Summary Report of Stakeholder Engagement

Airspace Change Request ACP-2021-032

Author(s):	David Walters (david.walters@altitudeangel.com)
Document Version:	1.2 (28 January 2022)

Figure 1 A Closer look at the Proposed Final TDA Shape at SFC-800ft AMSL Following Feedback ON CAA 1:250K England South Chart

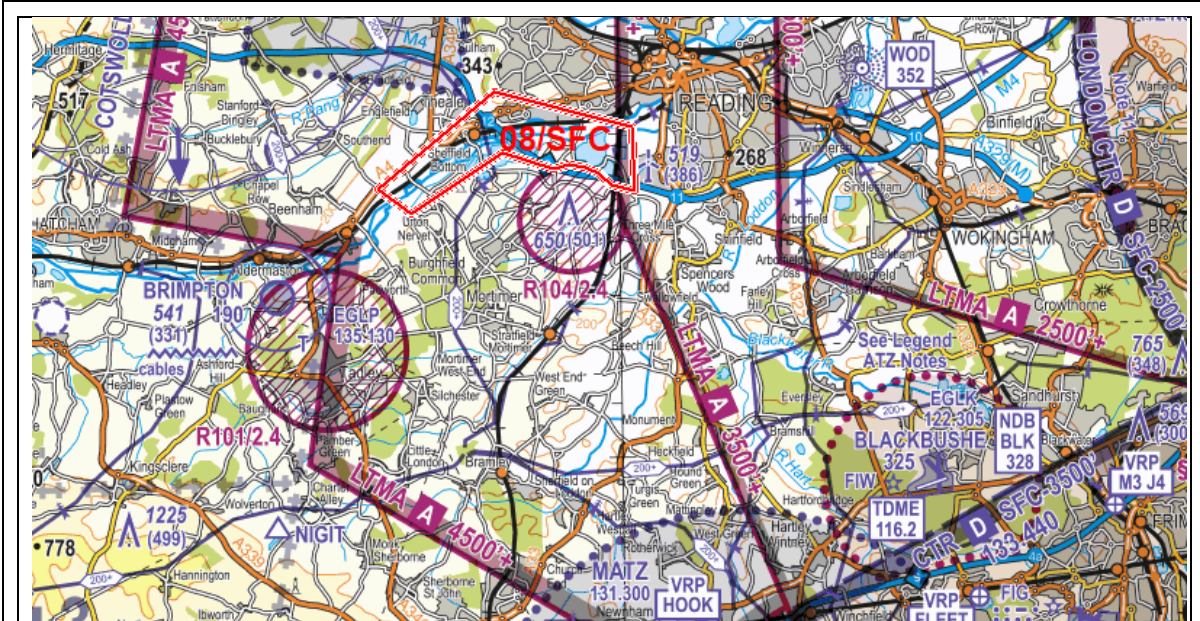
We have listened to the GA community response regarding congestion within the airspace due to low cloud cover at or below 1,000ft AGL. We have acknowledged this and agree that the TDA and our operations would not be active when cloud cover is this low.

Some raised questions about the proposed upper limit of the TDA and requested we look to achieve 600ft AMSL, as opposed to 800ft AMSL detailed in our application.

Note: The Arc shape butts up next to the R104 Airspace of Burghfield

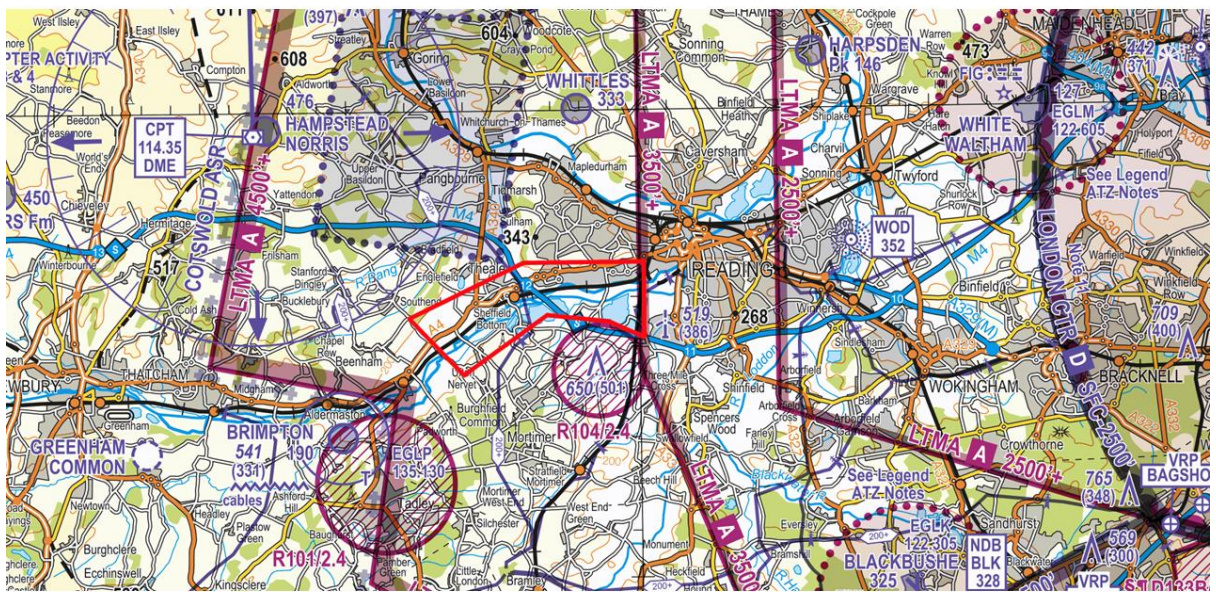
3. Whilst you have given detailed information on the area required for the TDA we would always request that this be presented on a current airspace chart, preferably the 1/4mil scale, considering the size of this proposed TDA. We appreciate that your Engagement Notice includes some representation but the chart used is not an appropriate scale. Actually, this issue is something we have consistently lobbied all sponsors and the CAA for as a fundamental requirement. The clue is in the name; it

is an *Airspace* Change Proposal where you need to engage with aviation stakeholders so it seems obvious that it would be necessary to represent the proposed Change on an *airspace* chart. This provides a level of clarity with regard to the impact any TDA could have on airspace users relative to existing airspace. It seems this is a common failure with virtually all UAV ACPs and we feel shows a level of ignorance of airspace matters. We are puzzled why the CAA don't insist on this as we cannot see them accepting an ACP from a major airport for revised airspace on a satellite map. The process is the same irrespective of what the Change is for so it seems sensible the same rules should apply. It would certainly enhance your application in the eyes of the CAA, I'm sure.

We have added an aviation chart to the uploaded and updated Stakeholder Letter V4 on the ACP Portal. We took the feedback from our first responses and uploaded the updated version. Since then we have obtained a digital copy of the VFR chart for the south and will be uploading it shortly. I do agree it would be better on the ACP planning tool if the CAA had the VFR Charts back loaded so we could draw directly on to them. It would be easier for everyone, I think!

Thanks, the 1:250,000 chart representation is much clearer and we appreciate your prompt and positive response to that request. It immediately shows proximity to any other airspace and any airfields and would be so much better if more drone sponsors were so motivated! It almost seems some purposely want to hide such proximities. A lesson for the CAA we think.

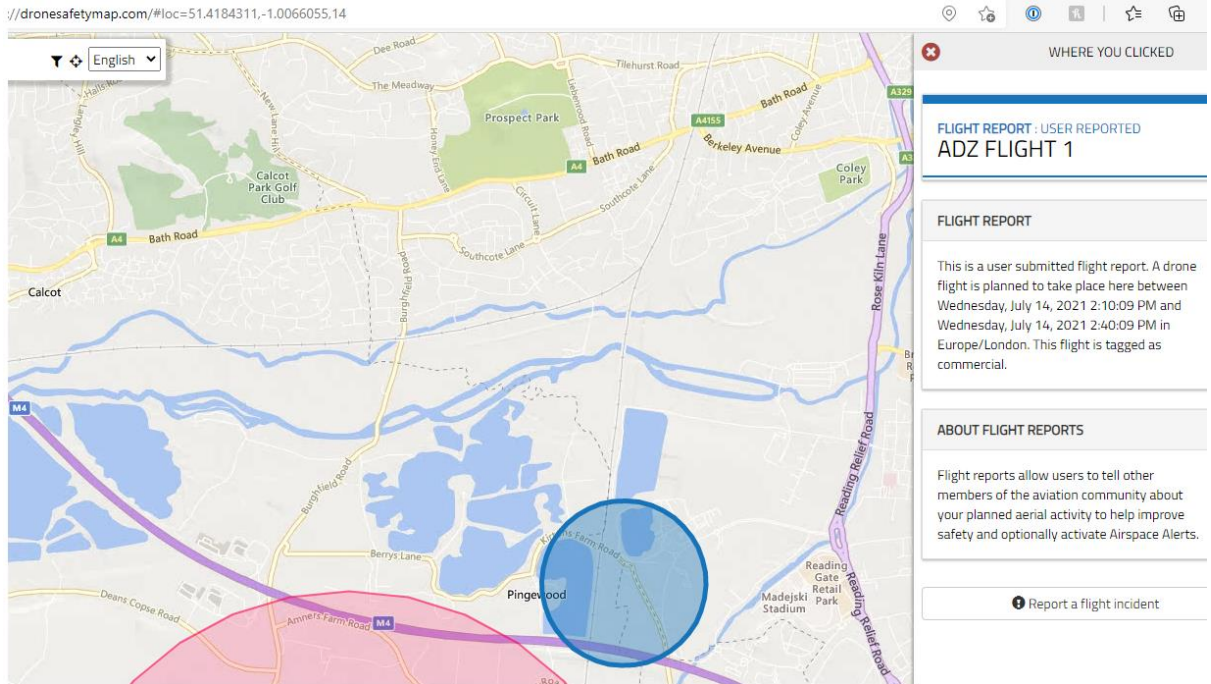
4. Whilst we support your efforts, in general terms, we would ask what your justification is for requesting a TDA in the location proposed, in particular because of the proximity to RAF Benson's MATZ stub, Restricted Airspace (RA) R104 and RA R101? We appreciate this may be close to your offices but that's not really a justification for potentially adversely impacting other airspace users. We appreciate that your TDA is proposed to be just 459ft AGL but that does only provide about 450ft clearance between the top of your TDA and the base of the Benson stub, where they appear to virtually contact. Again, this is where presentation on the appropriate airspace chart will add clarity. We understand that you wish to trial the

technology in an area where there will be other unconnected airspace users, but this does create a rather congested airspace area and, as we understand it, your technology is not approved for BVLOS operations in Britain thus far, although we are interested to understand more on that aspect.

Not sure how this mitigates the restriction resulting from the proximity of your TDA to the RAF Benson stub as far as GA traffic is concerned?

We have had a very positive response from MOD and are working on a CONOPS to support them, in addition to supporting Babcock (who are also supportive of the application) transiting through with its helicopter services. The TDA is a requirement at the moment for all BVLOS operations authorised by the CAA in the UK. It's this process we have been working through for the last two years. The flight approvals system is currently the same as deployed in various airports across the world by Altitude Angel for supporting and enabling drone operations in controlled airspace.

The DAA solution has been tested at a small airfield where we were able to collect supportive evidence over a relatively short period of time. We now have the masts deployed in Reading which are actively monitoring and tracking aircraft as we speak. We are also testing the system in the Reading location under VLOS and EVLOS conditions. The BVLOS Part of the testing at this location is the final step. Our aim is to provide evidence to the CAA at the end of the flight trials which, in this environment, our DAA solution can provide sufficient safety mitigations that BVLOS Operations using our technology no longer require a TDA.

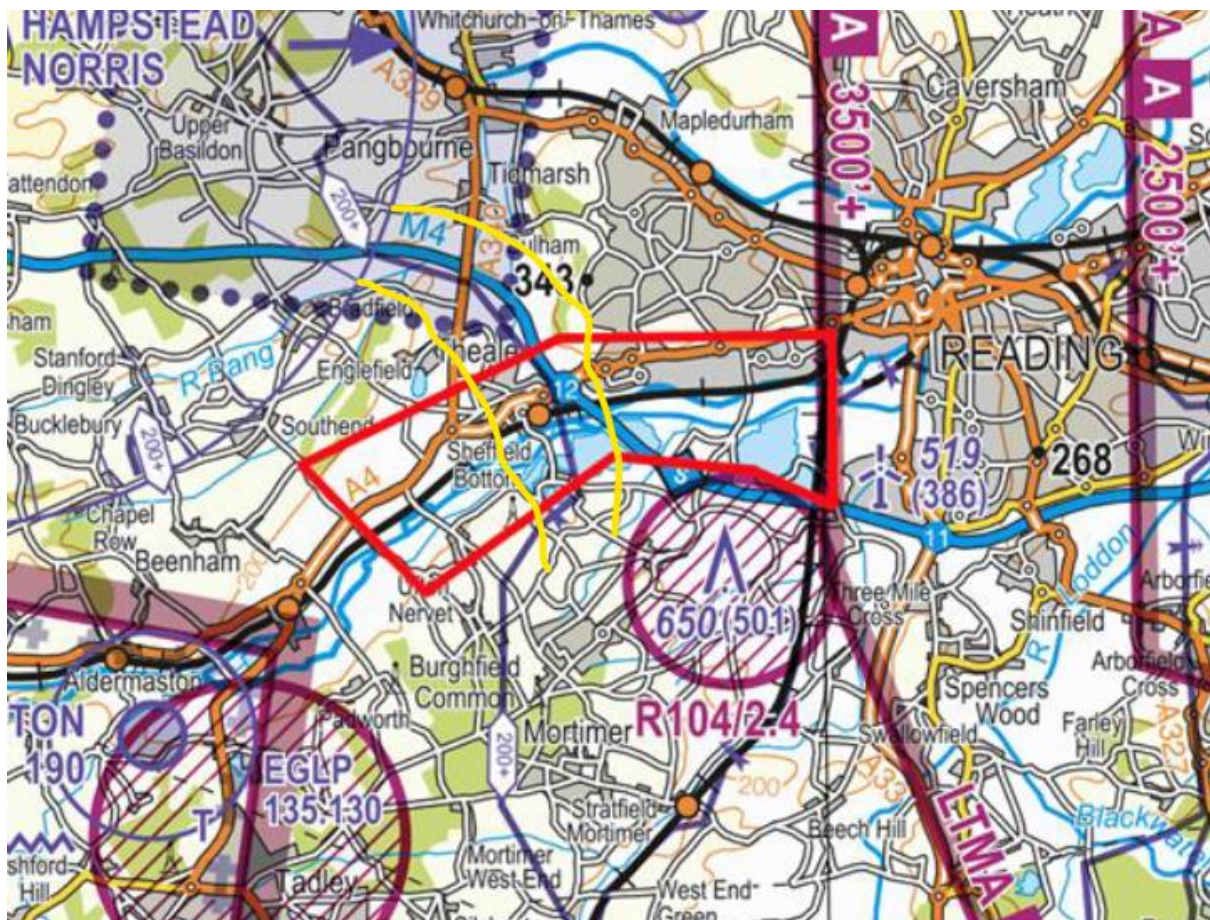
Hi,
National Grid have a need to inspect its powerline as shown in the diagram below, generally by helicopter SFC-600ft agl, but possibly by EVLOS drone SFC-400ft agl.

Will access/deconfliction be easily provided on request?

If our TDA is active whilst you're looking to cross or do an inspection, a telephone number will be posted within the NOTAM. This line is only active when the TDA is. We can discuss timings and hold operations until your clear or complete if needed.

We also have ADSB receivers deployed, along with other sensors that support our DAA of Manned Aircraft, so we should see you also.

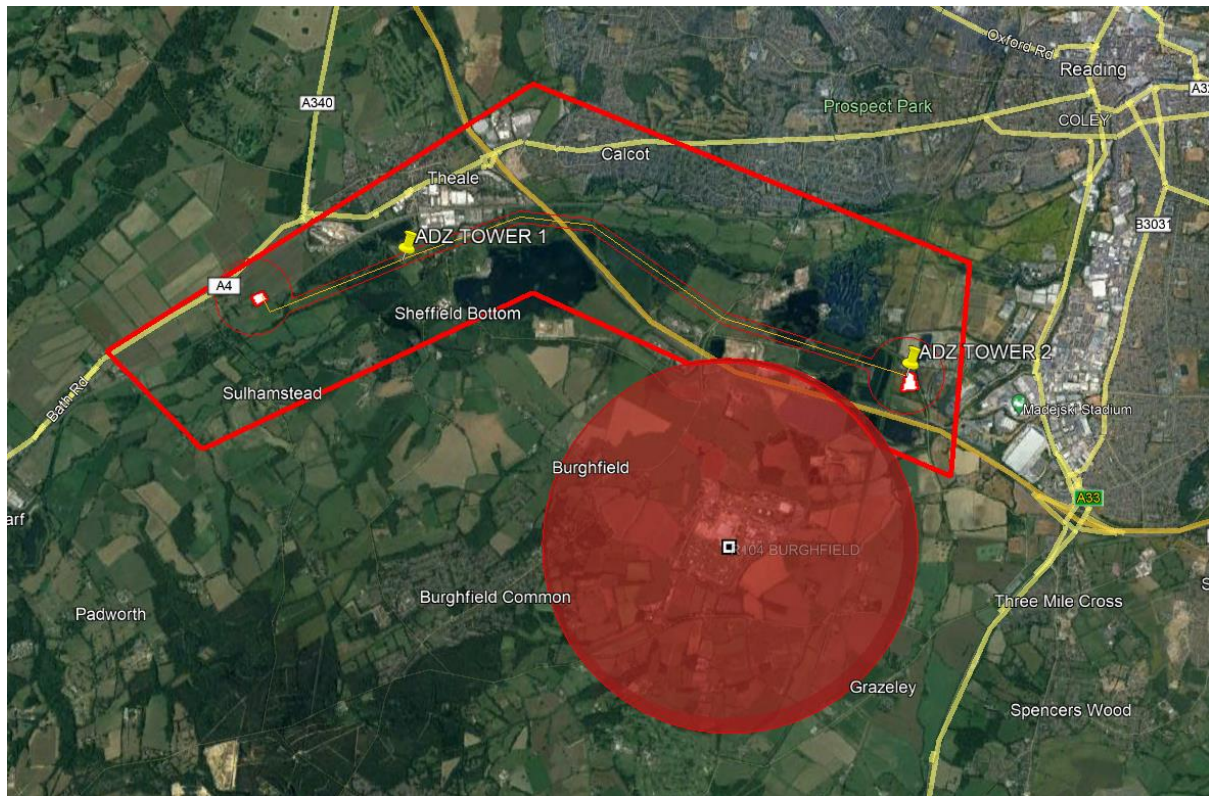
Thanks for your offer, I'll try and make one of the calls when our Pilots confirm attendance. However, I do have a couple of questions if you don't mind, I've looked at the VFR Chart and noticed your FDA is extremely close to our Restricted Airspace do they intersect at any point?

From Security point of view how will we know when you are flying? [REDACTED]

Our TDA Proposes to follow the outer edge of your Curve on R104. On our first submission there was a slight gap which the CAA asked us to close. The actual route the drones will fly is the orange centre line which is a good 350m away from the R104 TDA. The Red lines which sit either side of that is our emergency buffer zone. Then we have our TDA over the top of that.

With regards to flight activity, all of our flights are posted 48hrs in advance. Our TDA is only active during the period of drone activity too.

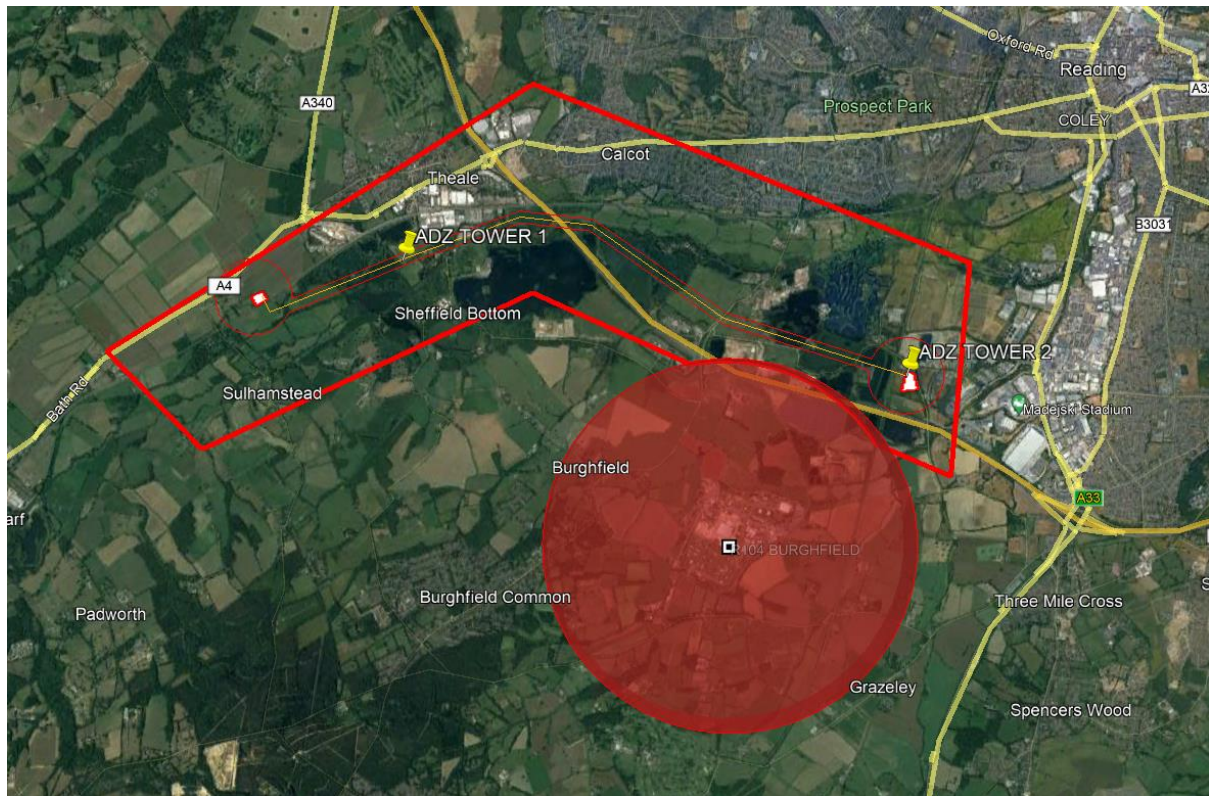
Thanks for your offer, I'll try and make one of the calls when our Pilots confirm attendance. However, I do have a couple of questions if you don't mind, I've looked at the VFR Chart and noticed your FDA is extremely close to our Restricted Airspace do they intersect at any point?

From Security point of view how will we know when you are flying? as we do have a Ministry of Defence Police response to unknown Drone Flights.

Our TDA Proposes to follow the outer edge of your Curve on R104. On our first submission there was a slight gap which the CAA asked us to close. The actual route the drones will fly is the orange centre line which is a good 350m away from the R104 TDA. The Red lines which sit either side of that is our emergency buffer zone. Then we have our TDA over the top of that.

With regards to flight activity, all of our flights are posted 48hrs in advance. Our TDA is only active during the period of drone activity too.
